Subject: Duke Energy Corporation  
Oconee Nuclear Station - Units 1, 2, and 3  
Docket Nos. 50-269, 50-270, and 50-287

Revisions to Topical Report DPC-NE-3003 In Support of  
Steam Generator Replacement  
Response to NRC Staff Request for Additional  
Information

Enclosed herein, please find the Duke Energy Corporation (Duke) response to the May 12, 2003 NRC staff's request for additional information concerning topical report DPC-NE-3003, Revision 1, "Mass and Energy Release and Containment Response Methodology."

### **Duke Power Response To Request For Additional Information**

**GOTHIC 7.0 - FATHOMS COMPARISON**  
**ROTSK STEAM LINE BREAK**  
**(Double-Ended Guillotine Break)**

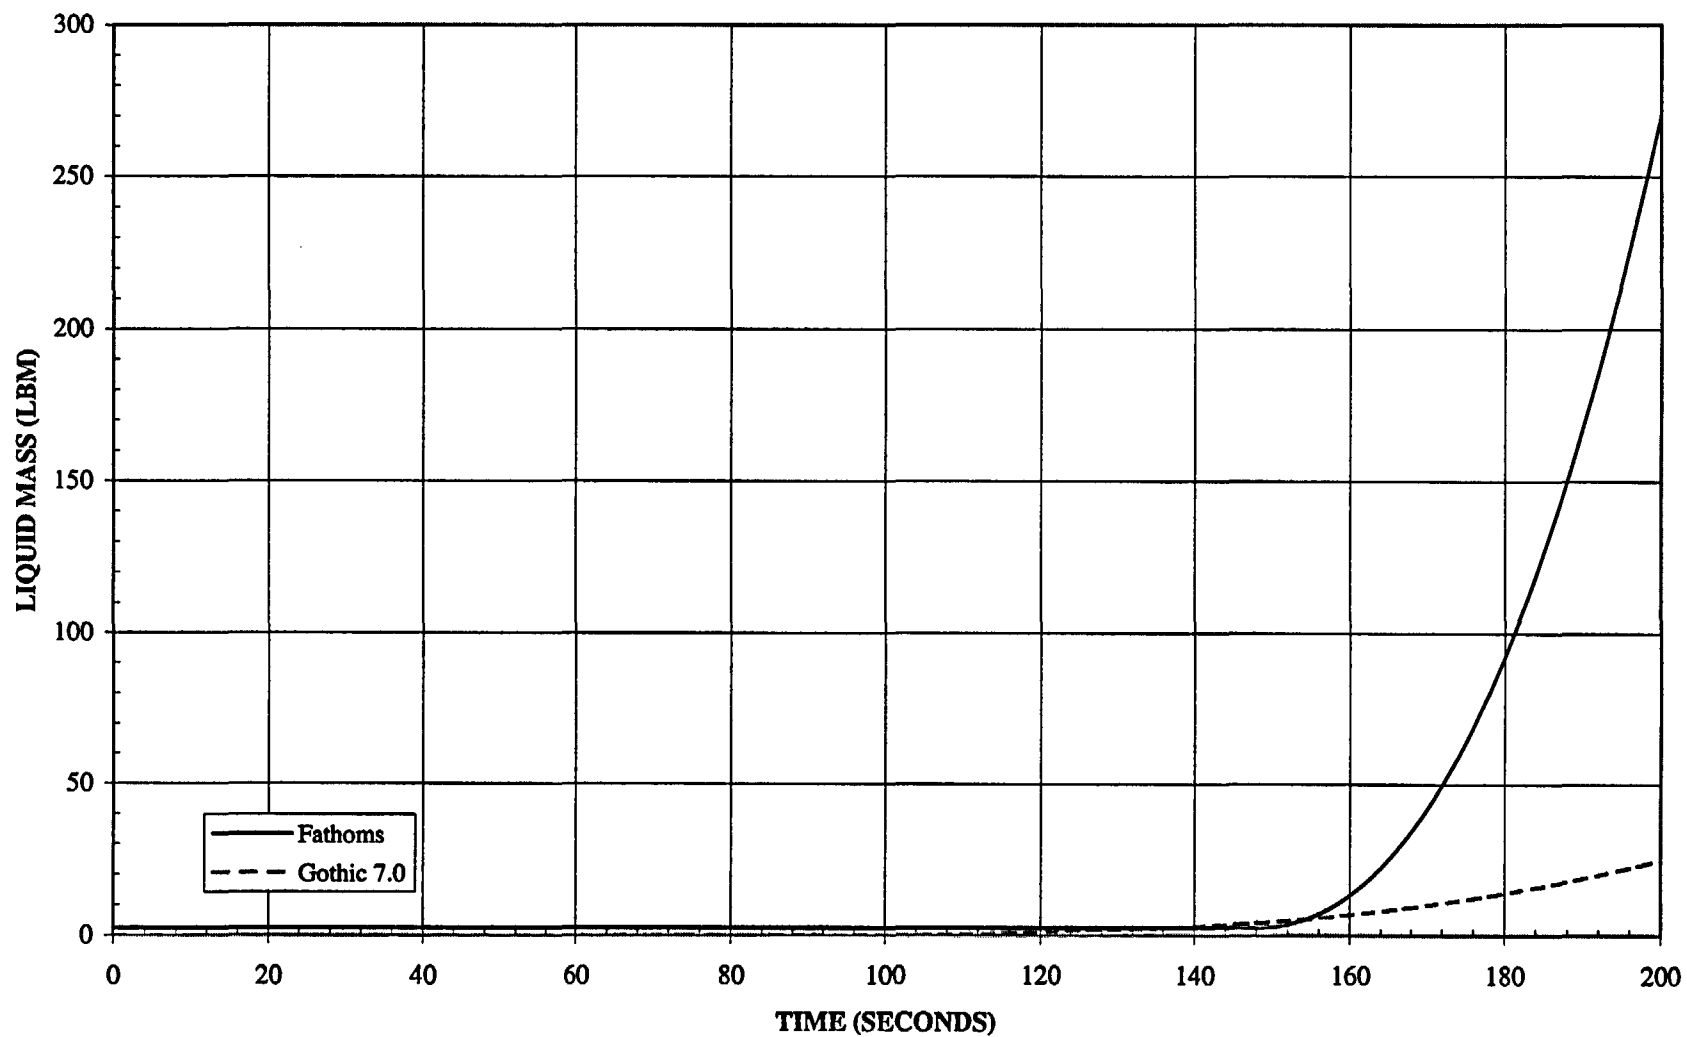
14. Show that GOTHIC and FATHOMS calculations result in the same pressures, temperatures, sump temperatures, etc. for the design basis LOCA and main steam line break events. If they do not, explain differences in terms of the differences in models between the two codes. (See Question 1.)

Response: Refer to the response to Question #3 for LOCA. The results of the 6 code comparison analyses for the main steam line break are given in Table 14-1 and the figures that follow. The containment response following a main steam line break event for the ROTSG was performed to compare the results from FATHOMS 2.4 and GOTHIC 7.0. In general, the pressure and vapor temperature responses are very similar. GOTHIC 7.0 predictions for peak pressures are slightly lower on the smaller break sizes (~0.3 psi) and slightly higher for larger break sizes (~0.95 psi). The peak vapor temperature responses predicted by GOTHIC 7.0 overall are slightly lower (~12°F). For larger break sizes, the higher pressure predicted by GOTHIC 7.0 may be attributed to additional steam generation from the improved interface heat and mass transfer models and from the drops that are generated due to dripping. The slightly lower pressure for smaller break sizes may be attributed to additional droplets in the atmosphere. The slightly lower vapor temperature and liquid temperature in GOTHIC 7.0 for all break sizes may be attributed to additional droplets in the atmosphere also. This effectively increases the heat capacity of the atmosphere and reduces the temperature rise for a given energy addition. As discussed in the responses to Questions #1 and #3, more liquid is predicted to remain in droplet form in GOTHIC 7.0 which results in less liquid mass in the sump. In addition, the lower sump temperature predicted by GOTHIC 7.0 may be attributed to the addition of the second energy equation for the drops and the improved heat and mass transfer models in GOTHIC 7.0.
